CITY OF ALBUQUERQUE

**RE: Freddy's (Formerly "Whataburger"), 111 Coors Blvd. NW
Grading and Drainage Plan
Engineer's Stamp Date 6-03-2015 (File: K10-D001B)**

**RE: FREDDY'S, 111 COORS BLVD. NW
GRADING AND DRAINAGE PLAN
ENGINEER'S STAMP DATE 5-18-2015 (K10-D001B)**

GRADING AND DRAINAGE PLAN

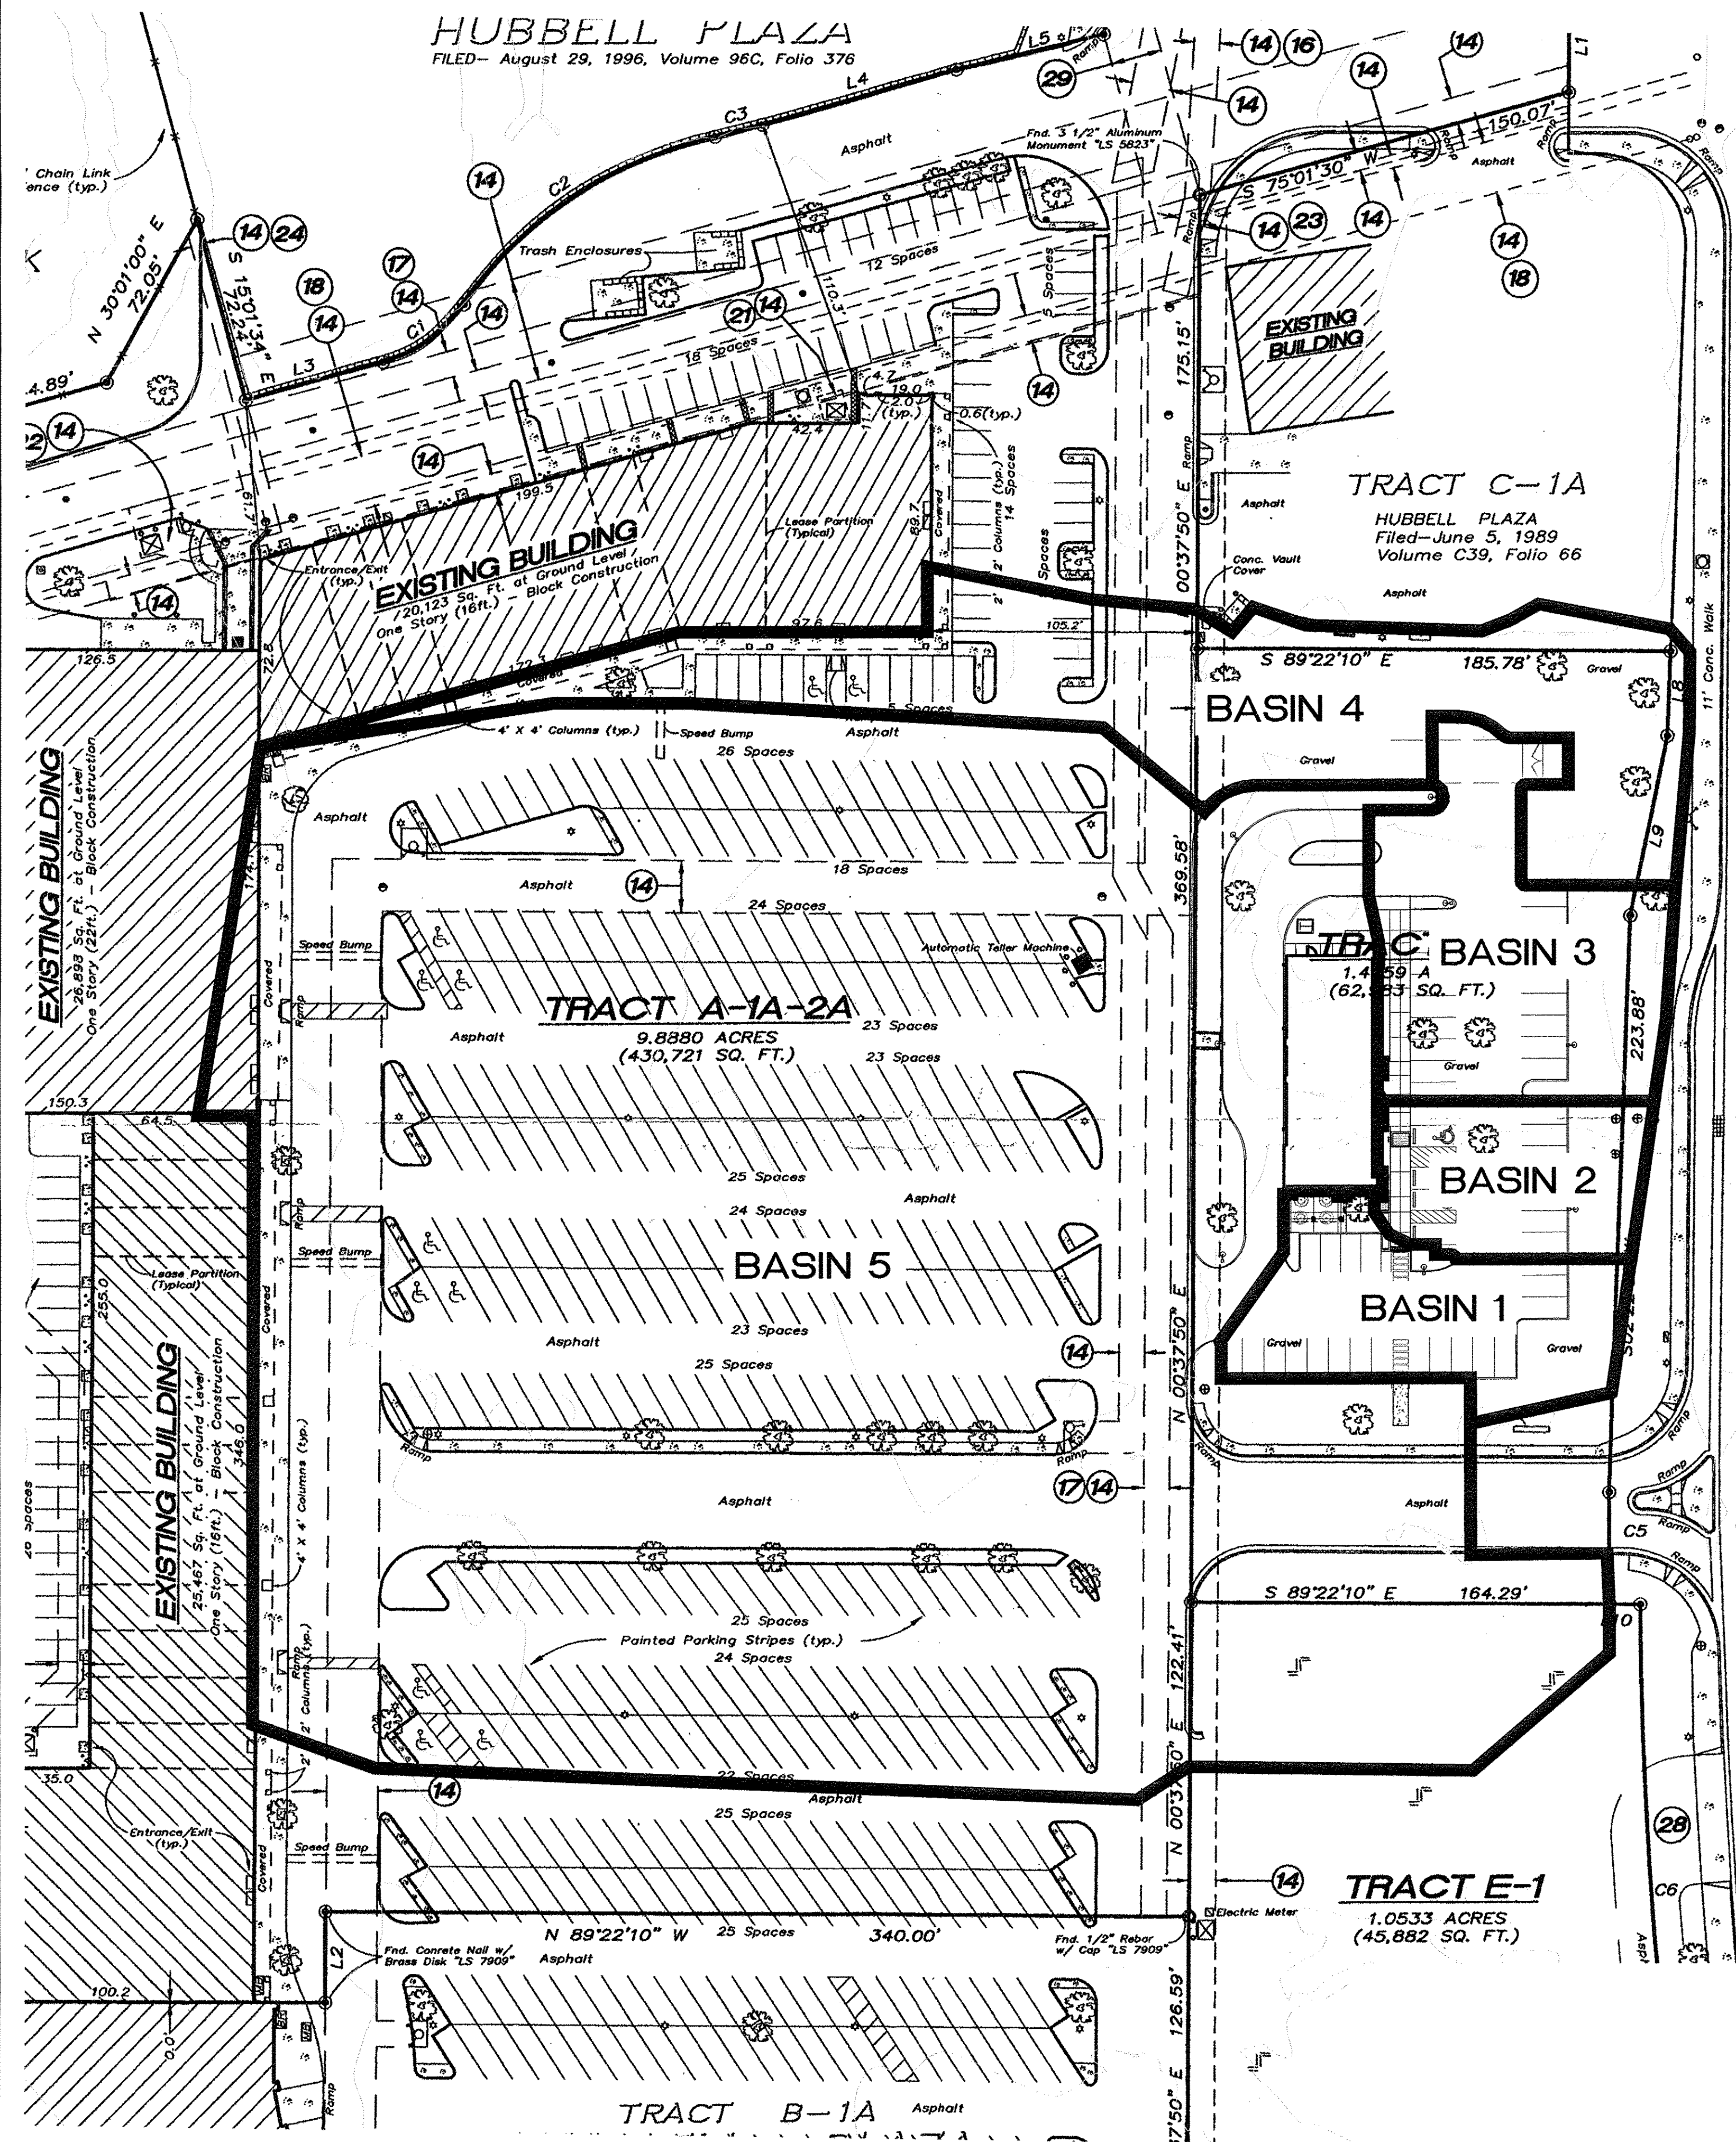
- 1) A new grading and drainage plan must be submitted based on the updated site plan which addresses EPC Comments. Ensure that the new site layout incorporates the same detention pond sizing as the old site layout.
- 2) The electronic submittal (Engineer's stamp date - 6/03/15) does not match the hard copy submittal (Engineer's stamp date - 5/18/15). The 6/03/15 plan addresses the latest and greatest comments (e-mail dated 6/01/15) that ask for additional existing spot elevations at the accessways from the shopping center parking lot and the grease trap for the trash dumpster.

1. An agreement from adjacent property owner to the west is required to acknowledge the increase in 100-year water surface elevation to what is shown on the plan at a distance of "x" above existing ground.

2. Put back the spot elevations that were originally on the conceptual plan showing the relationship between top of water surface elevation and top of existing ground. Ensure that the added water surface depth does not adversely affect the property to the north or south and that drainage is still being directed toward the double "D" inlet.

3. Add a grease trap connection for the dumpster with a couple of added spot elevations showing drainage to the grease trap.
Response: The grease trap drain for the dumpster has been added to the grading plan and labeled. Spot elevations for the drain and dumpster area have been added to assure drainage is directed towards the drain. The connection to the grease trap has been accounted for in the utility plan.

Response: Included with this submittal is a signed agreement letter from the property owner of Tract A1-A-2A to the west stating that they acknowledge the change of the maximum water surface elevation in the parking lot of said tract.

Response: Spot elevations along the curb on the western property line have been added along with flow arrows to assure that positive drainage is still directed towards the Double D inlet.
